CP&L**Carolina Power & Light Company**Robinson Nuclear Plant
3581 West Entrance Road
Hartsville SC 29550**MAY 27 1999**RNP File No: 13510HA
Serial: RNP-RA/99-0025United States Nuclear Regulatory Commission
Attn: Document Control Desk
Washington, DC 20555H. B. ROBINSON STEAM ELECTRIC PLANT, UNIT NO. 2
DOCKET NO. 50-261/LICENSE NO. DPR-23REQUEST FOR TECHNICAL
SPECIFICATIONS CHANGE ULTIMATE HEAT SINK (UHS)

H. B. ROBINSON STEAM ELECTRIC PLANT, UNIT NO. 2

REQUEST FOR TECHNICAL SPECIFICATIONS CHANGE
ULTIMATE HEAT SINK (UHS)

Figure 2 - Double Ended Pump Suction Break - Minimum ECCS - Pressure

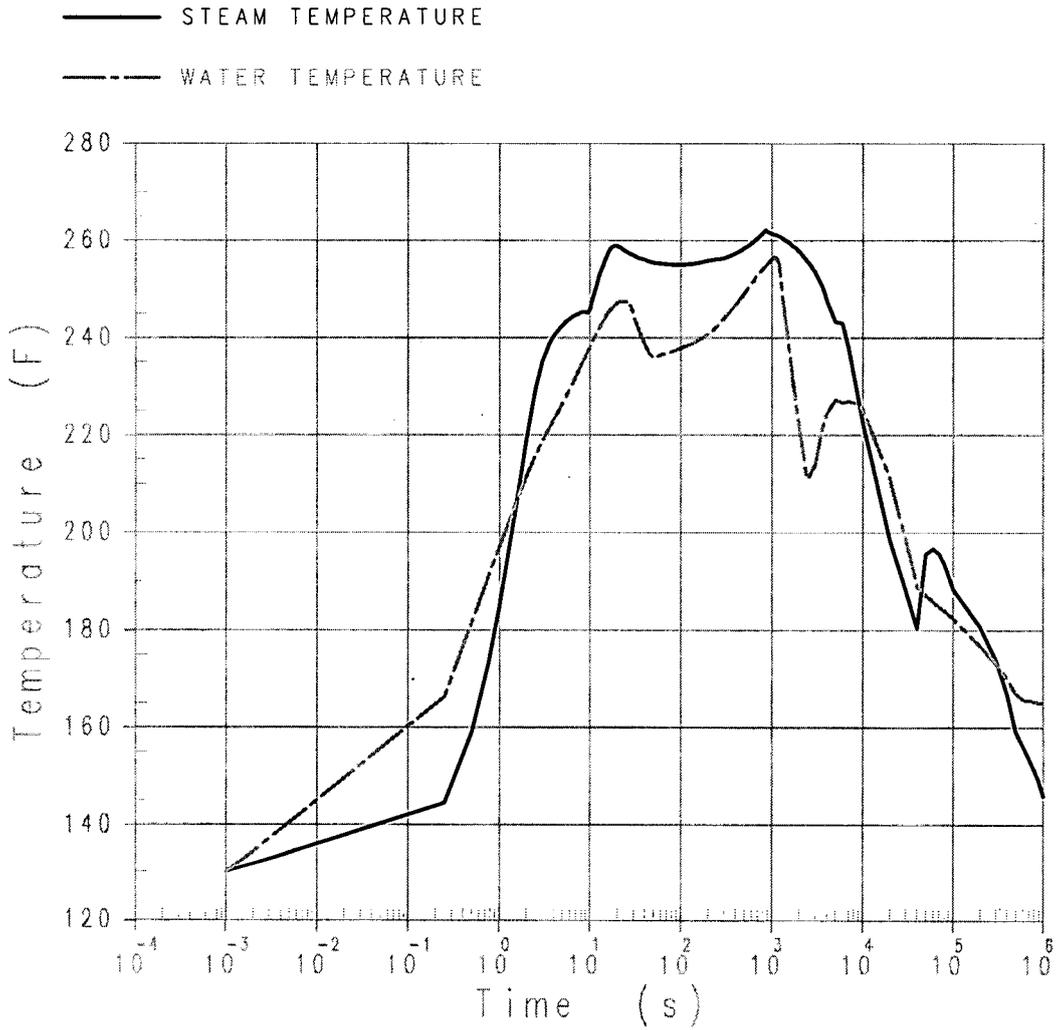
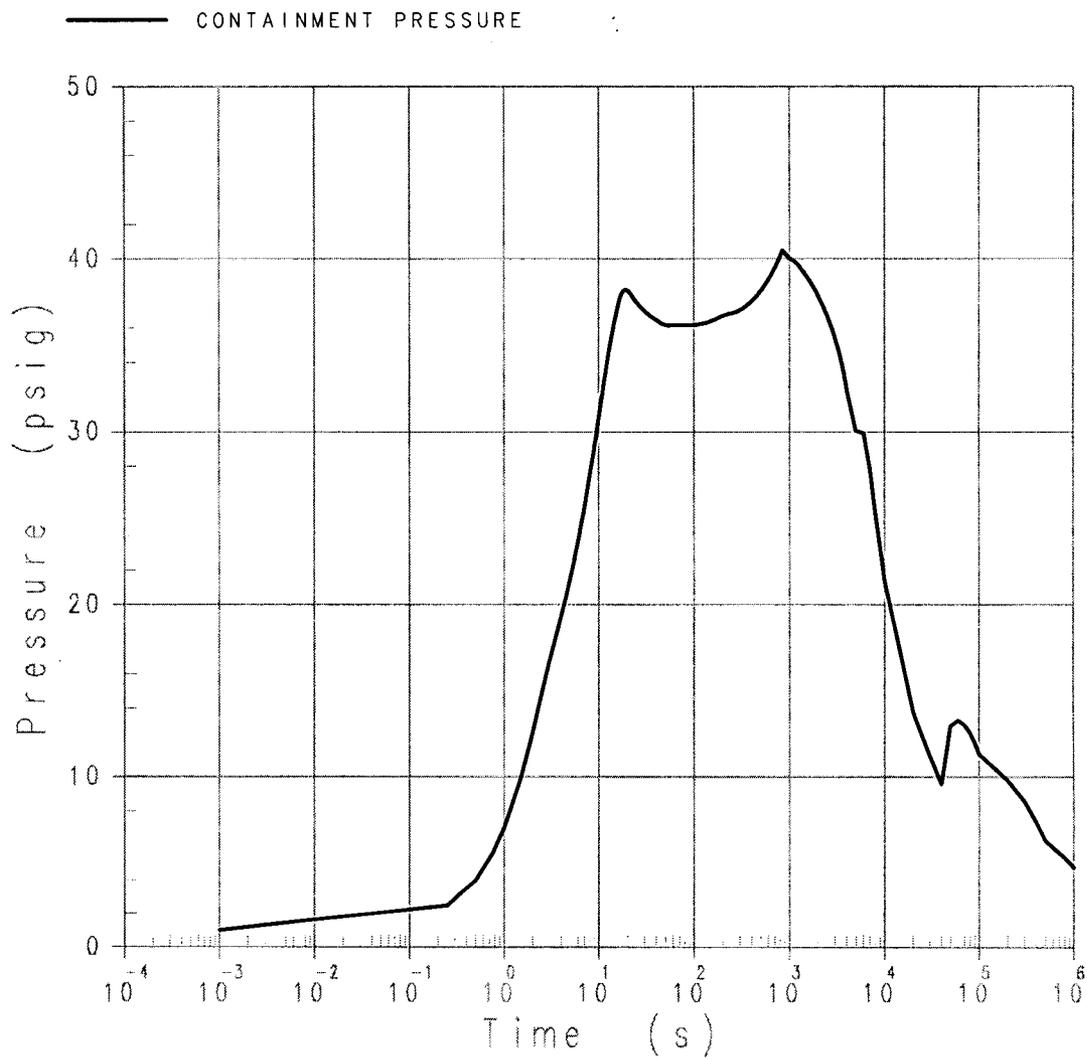
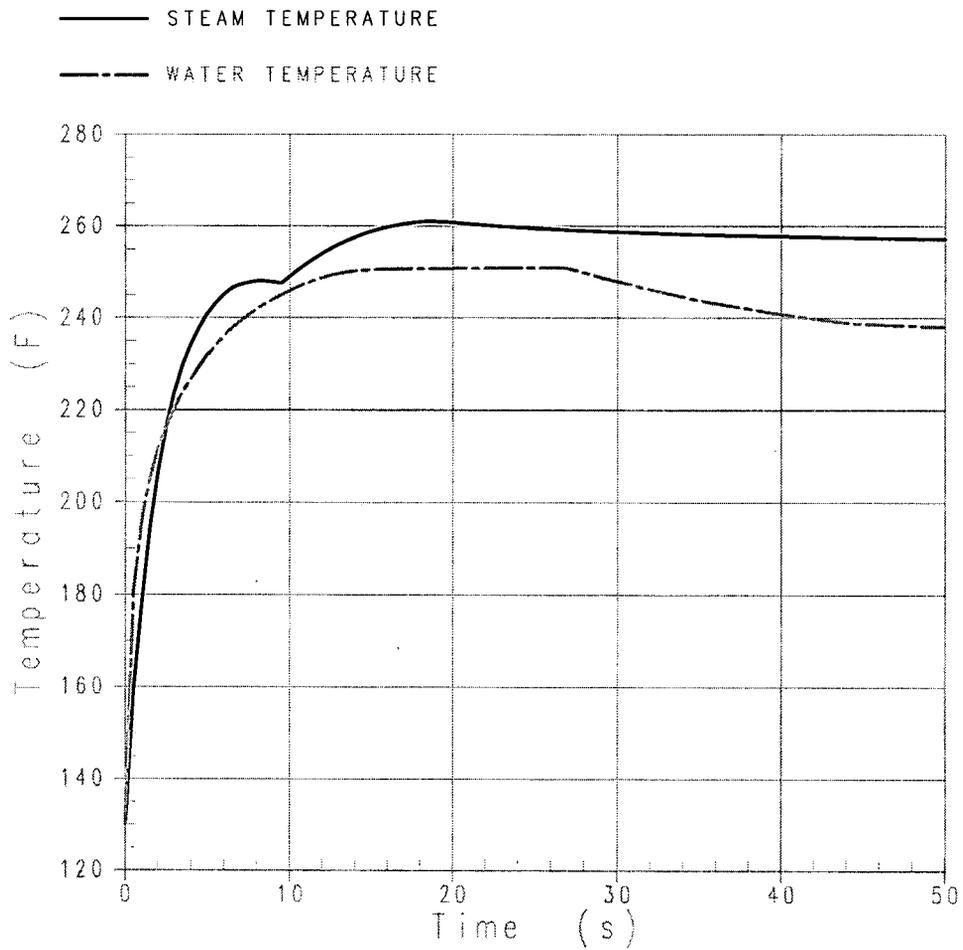
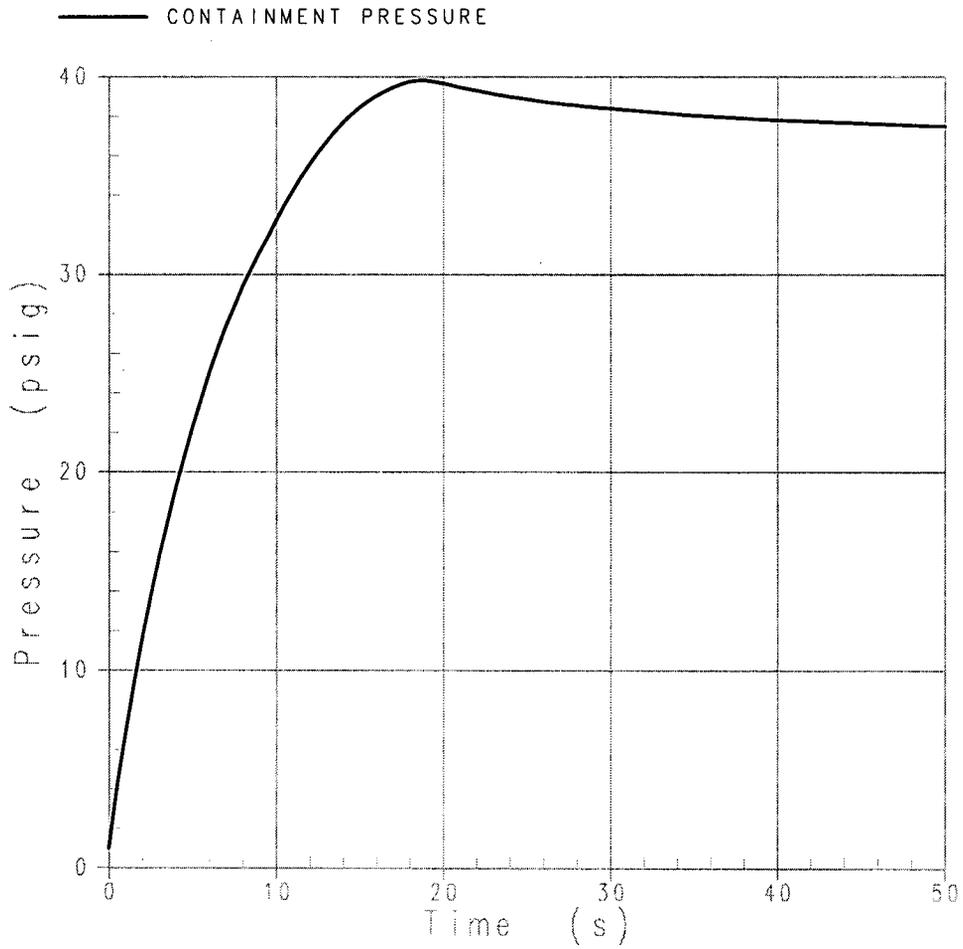
The containment pressure and temperature results from each of the large break LOCA cases are shown in Figures 1 through 4 and Table 7, "LOCA Containment Response (COCO) Results." All cases resulted in a peak containment pressure that was less than the containment design pressure of 42 psig. The new large break LOCA containment analysis response result of 40.5 psig represents a change in the margin of safety for the containment as defined in the NRC Safety Evaluation (SE) of Amendment 79 to the Technical Specifications dated April 4, 1984. The margin of safety was defined by the SE as 2 psig which was the difference between the containment design pressure of 42 psig and the previous analysis result of 40 psig. The Technical Specifications allowable upper pressure limit for normal operation was chosen in Amendment No. 79 to be $\frac{1}{2}$ of the margin of safety, defined as the difference between 42 psig and 40 psig, or +1.0 psig. The new analysis result represents a decrease in that margin of 0.5 psig. However, since the new analysis value assumes an initial containment pressure of +1.0 psig, which is the current maximum allowed Technical Specification value, and the previous analysis assumed an initial containment pressure of 0 psig, no change to the allowed containment pressure during normal operation is proposed.

CS initiates on a Containment High High Pressure signal, which has a NOMINAL TRIP SETPOINT of 10 psig. Figure 2 shows that containment pressure reaches 10 psig within the first few seconds after the initiation of a large break LOCA. CS flow out of the spray header initiates about 23 or 38 seconds (Table 4) after containment pressure reaches 10 psig. The suction of the CS pump is shifted from the RWST when RWST decreases to 9%, which occurs between about 63 minutes to 77 minutes (See Table 4) after the start of a large break LOCA. To accomplish the shift, the CS pumps must be stopped. The CS pump circuit breakers have an anti-pump feature that will prevent the CS pump motors from being restarted after being stopped while the original actuation signal is present. Figure 2 shows that containment pressure is above 10 psig when the switchover is required, hence, CS actuation circuitry must be blocked during the switchover to allow the CS pumps to be restarted manually upon completion of the switchover for further containment heat removal and pressure reduction. For the large break LOCA inside containment, the analysis assumed that CS is reinitiated at 100 minutes. The analysis shows that the containment pressure will be above 10 psig when recirculation is switched from the cold-leg to the hot-leg. In accordance with current procedures and system capabilities, CS will not be reinitiated after recirculation is switched from the cold-leg to the hot-leg.

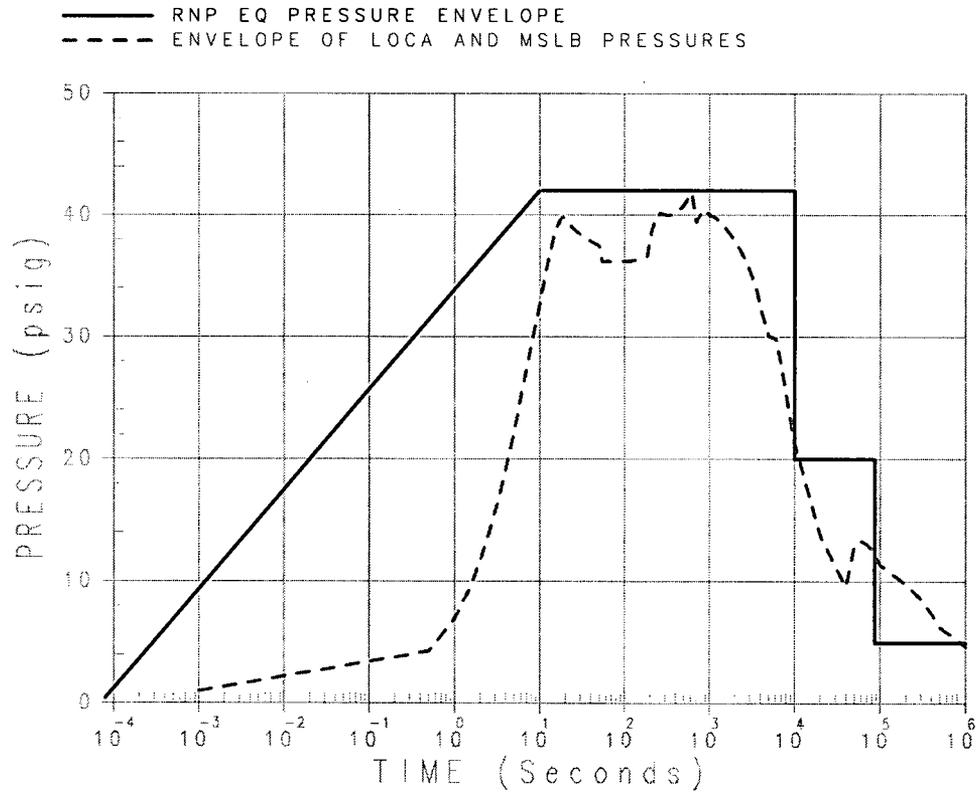
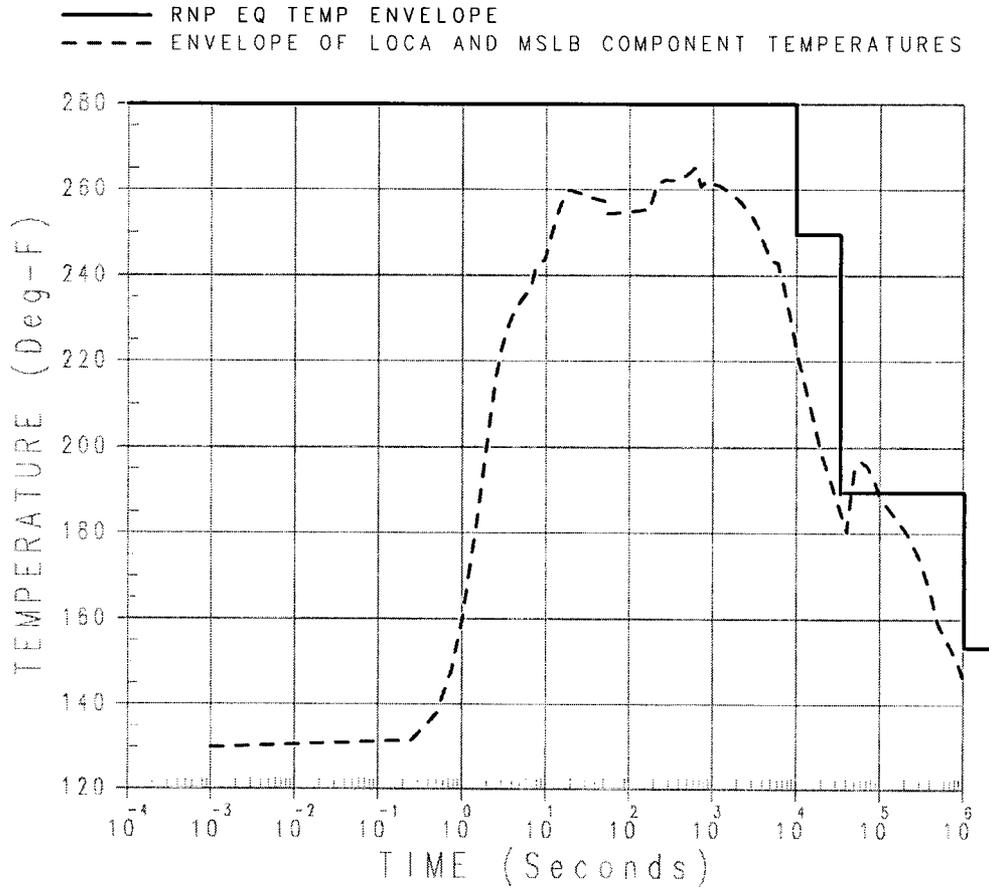
The environmental qualification of equipment required to operate during a MSLB was evaluated using the pressure and temperature profiles in Figures 5 and 6. The new accident temperature profile is generally bounded by the profile used for qualification testing of components, but since the accident profile exceeds the qualification profile in some cases, an accident degradation equivalency via the Arrhenius calculation was used to demonstrate that the components are qualified to the new accident temperature profile. Note that the component temperature profile shown on Figure 6 was a separate analysis run with initial containment pressure at 13.7 psia to maximize the component temperature for environmental qualification. The new accident pressure profile is also generally bounded by the pressure qualification profile. Equipment qualification data packages were evaluated for cases that were not enveloped by the qualification profile to demonstrate that the equipment are qualified to the new accident pressure profile. Therefore, the equipment required to operate during a MSLB is qualified for the environmental conditions that will be experienced inside containment.

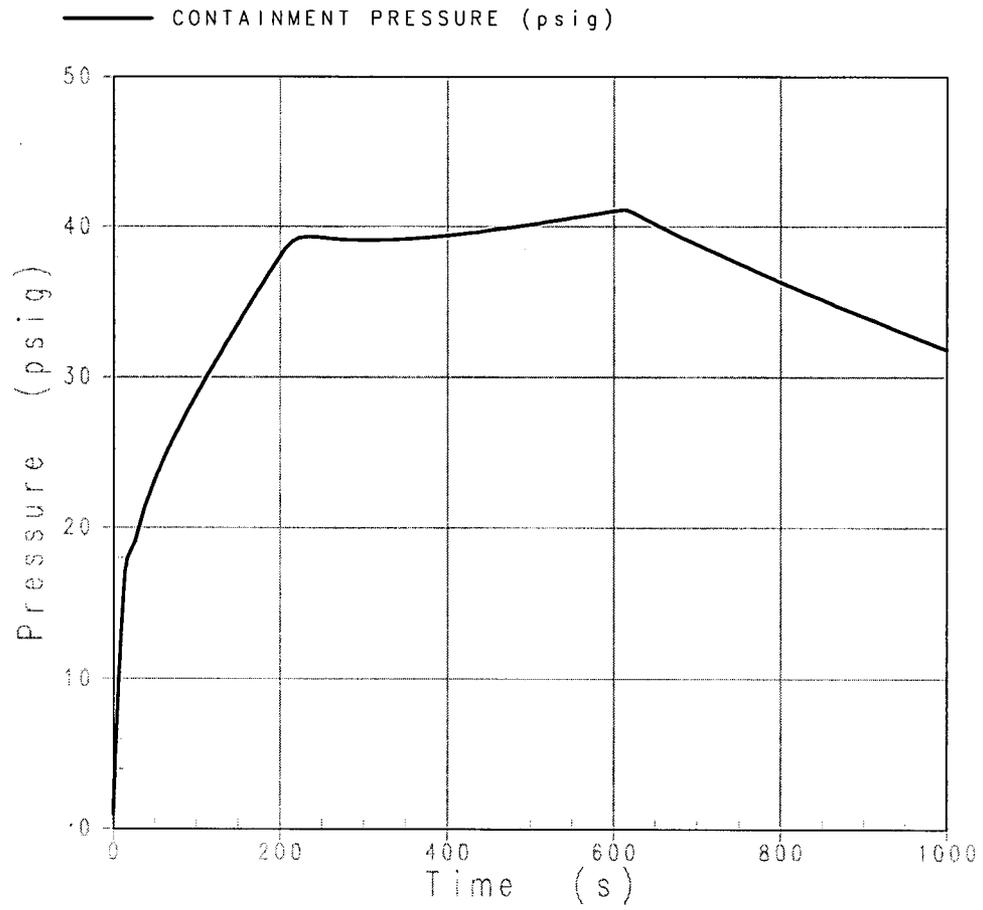
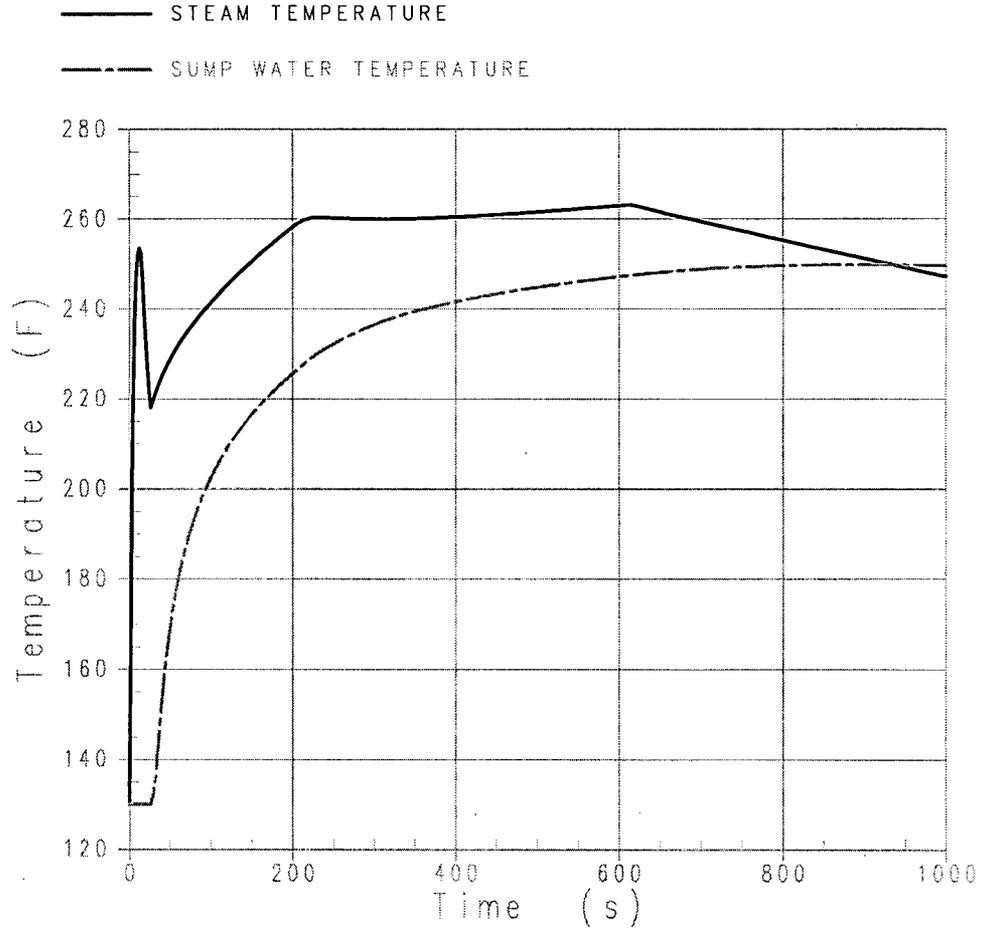
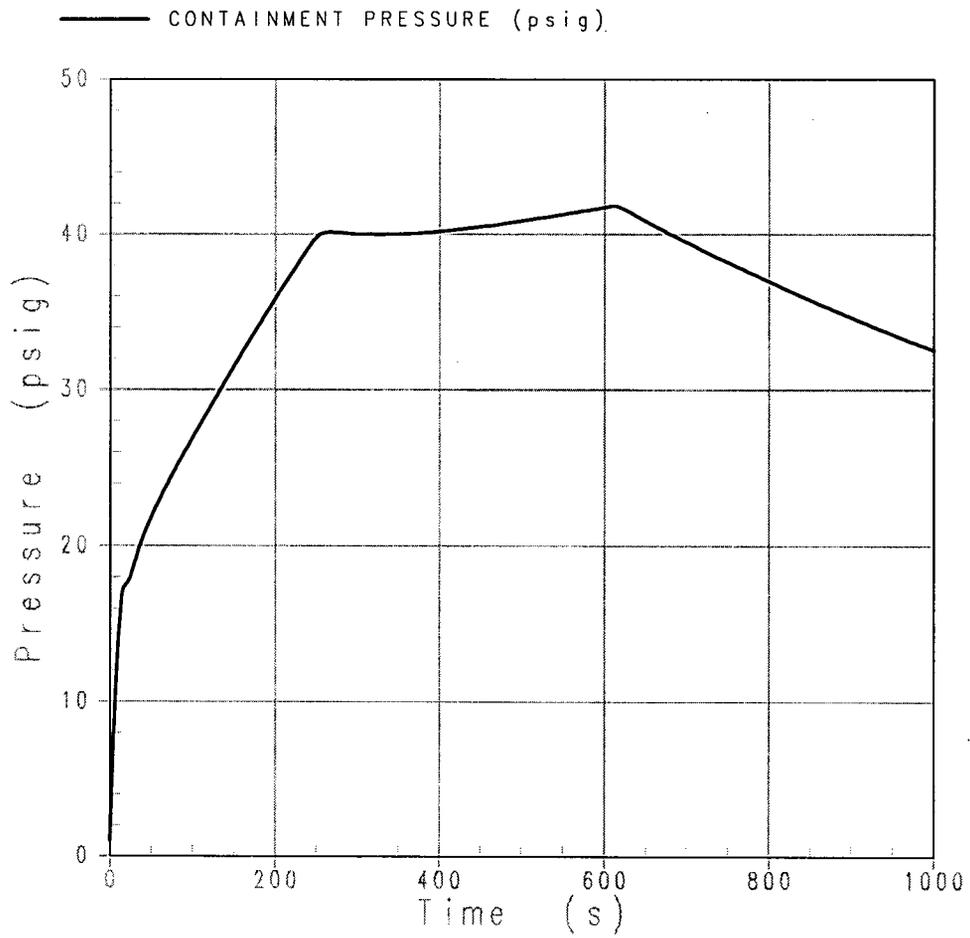
The containment temperature and pressure results for two of the MSLB cases are shown in Figures 7 through 10 and in Table 10, "MSLB Containment Response (COCO) Results." Table 10 summarizes the various MSLB cases analyzed. The limiting containment temperature resulting from a MSLB is for the 102% case with the single failure of one MFRV. The limiting temperature of approximately 274°F was reached at approximately 35 seconds into the event.
